# Construction Traffic Management Plan – Orchard Hills Station

SMWSASSM-PLD-OHE-TF-PLN-000001

Parklife Metro D&C

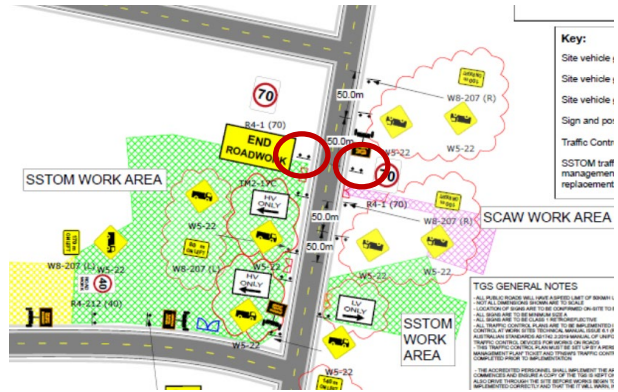
1.6. 40 km/h road work signs have been installed for the westbound direction on Lansdowne Road, however, these have not been shown in the TGS.

NOTE ONLY
